SUBJECT: AMENDMENT NO.142 TO FACILITY OPERATING LICENSE NO. DPR-43 -
KEWAUNEE NUCLEAR POWER PLANT (TAC NO. MA1557)

KEWAUNEE NUCLEAR POWER PLANT

AMENDMENT TO FACILITY OPERATING LICENSE

Amendment No. 142
License No. DPR-43

FIGURE TS 2.1-1

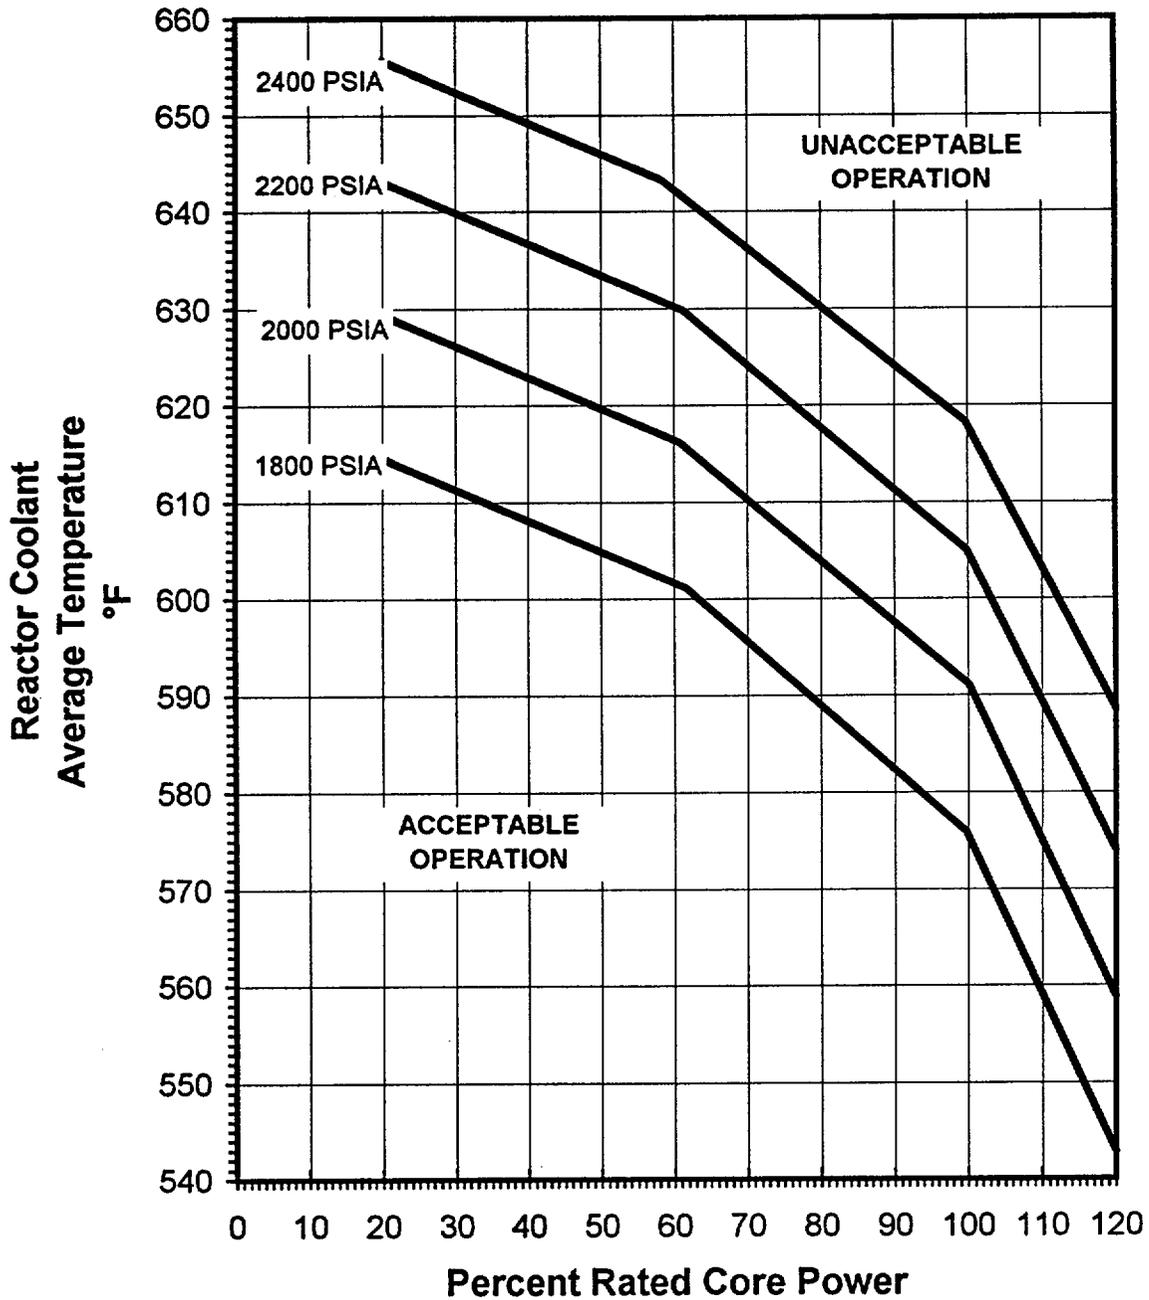
1) Figure 2.1-1 and TS B2.1 - Core Safety Limits

The core safety limits (maximum core powers as functions of the RCS pressure and temperature) are revised to reflect the use of the HTP correlation and its associated DNBR safety limit, RCS flow, peaking factors and fuel design. Since the core safety limits are calculated based on the approved methods for licensing applications and the acceptable results of the transient and accident analyses, the staff concludes that the revised safety limits are acceptable.

FIGURE TS 3.10-1

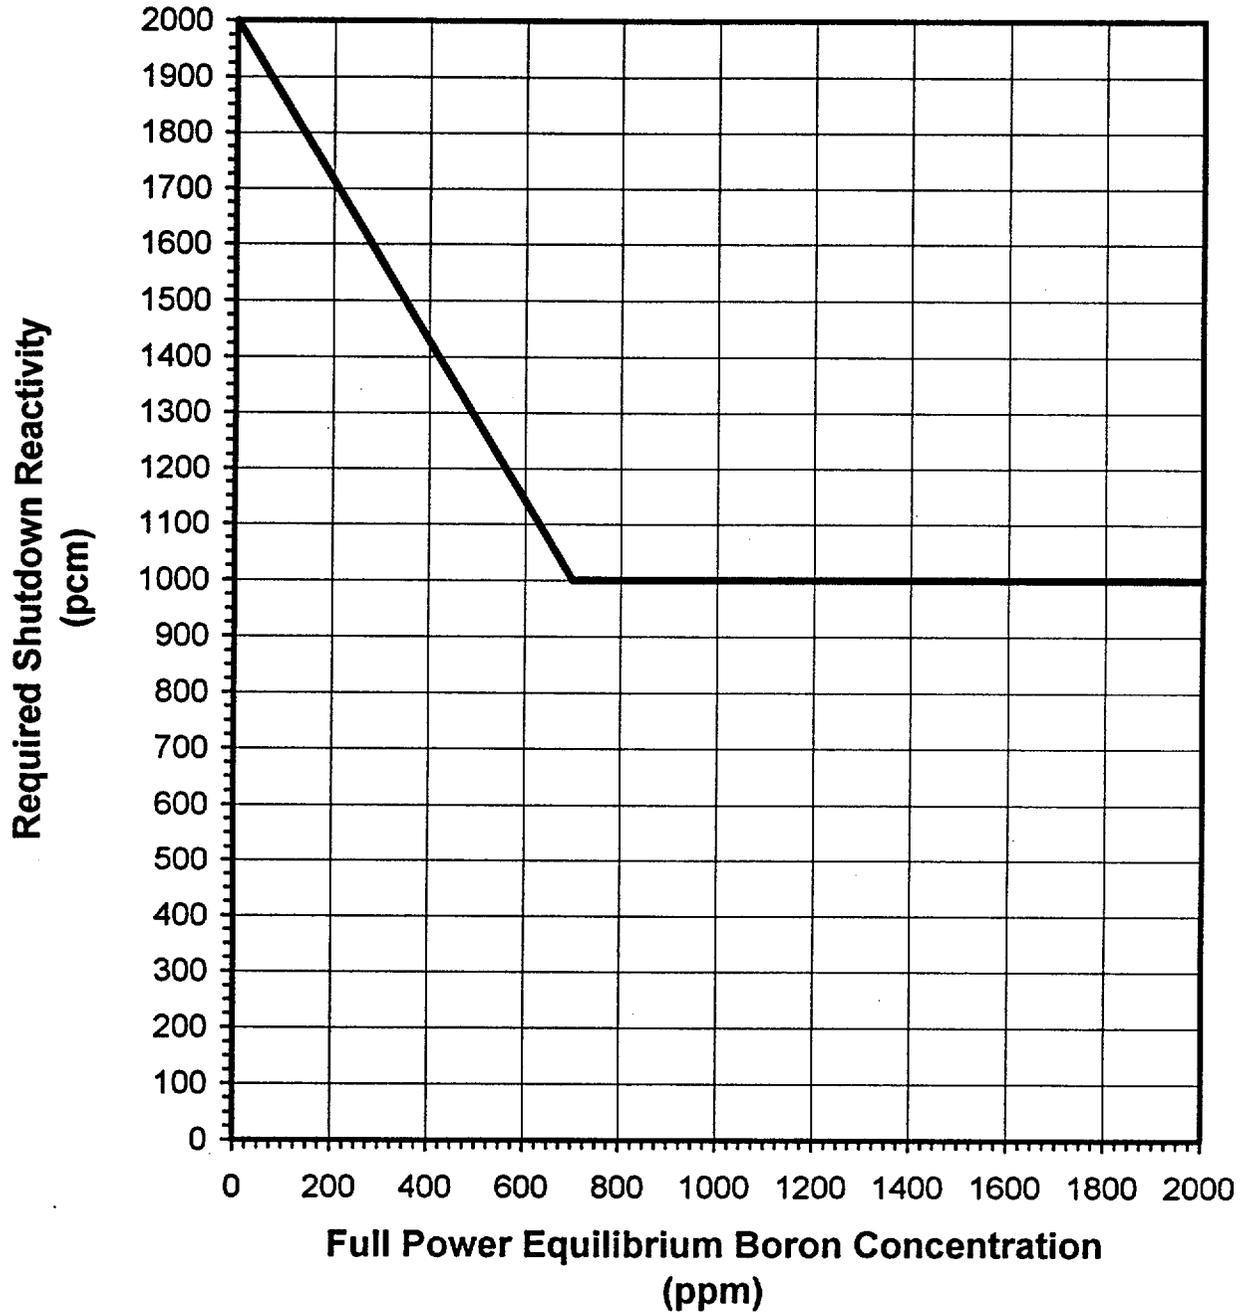
7) Figure 3.10-1 - Required Shutdown Reactivity Vs. Reactor Boron Concentration

This figure represents a relationship between the required shutdown reactivity reactor boron concentration. The limits for the shutdown are not changed. The required shutdown reactivity line is extended from 1300 ppm to 2000 ppm to account for the 18-month fuel cycle. The existing values are not changed in the safety analysis or in the TS. Therefore, the proposed TS is acceptable.

FIGURE TS 3.10-2

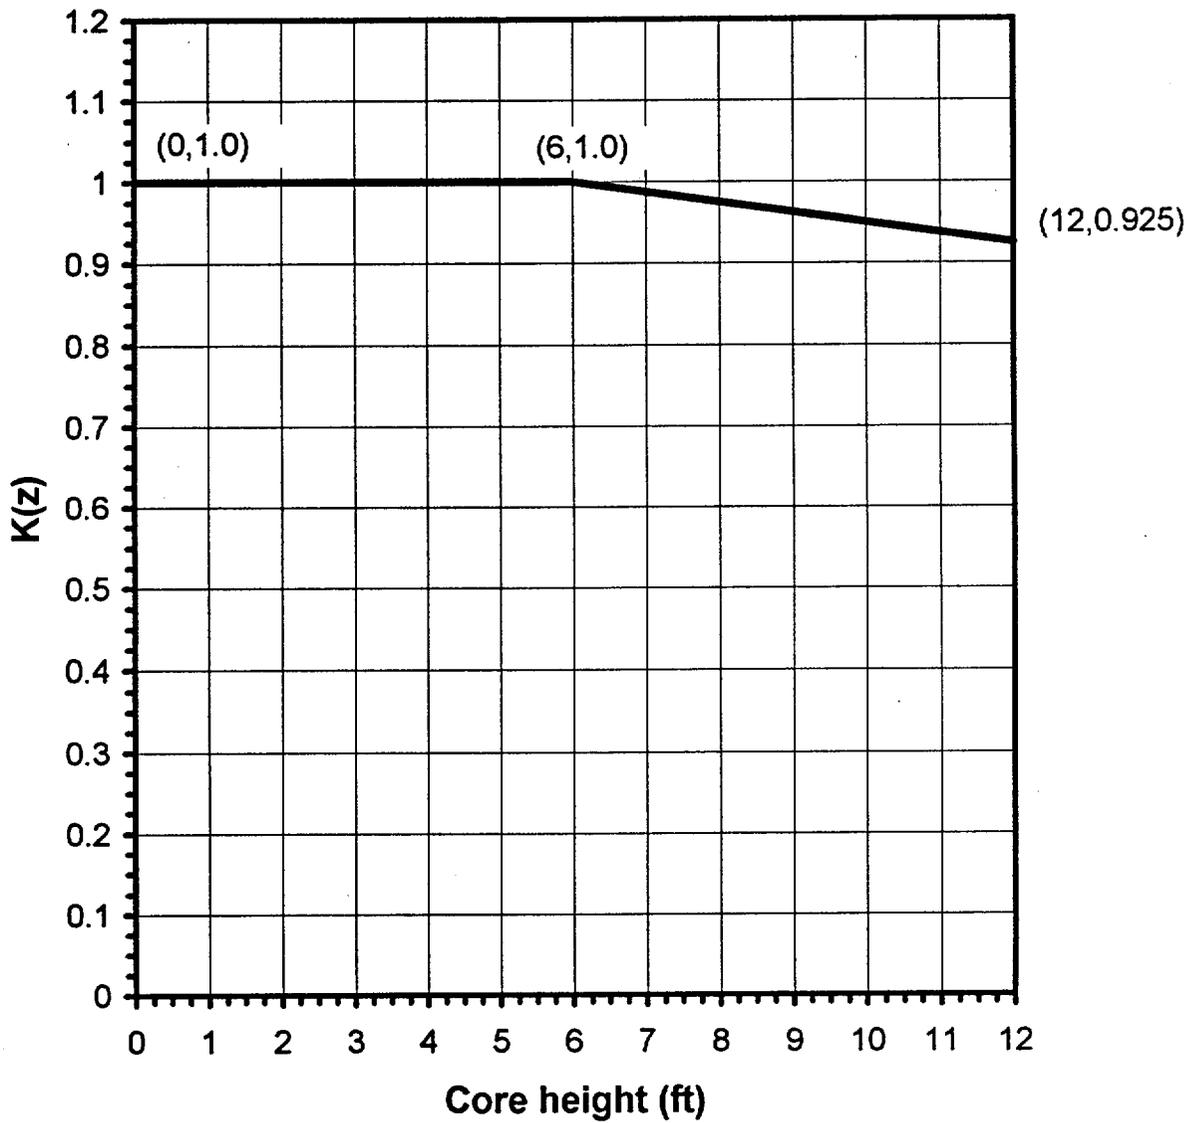
8) Figure TS 3.10-2 - Hot Channel Factor Normalized Operating Envelope

This figure represents the hot channel factor normalized operating envelope. It is revised to reflected the values used in the acceptable safety analyses and is, therefore, acceptable.
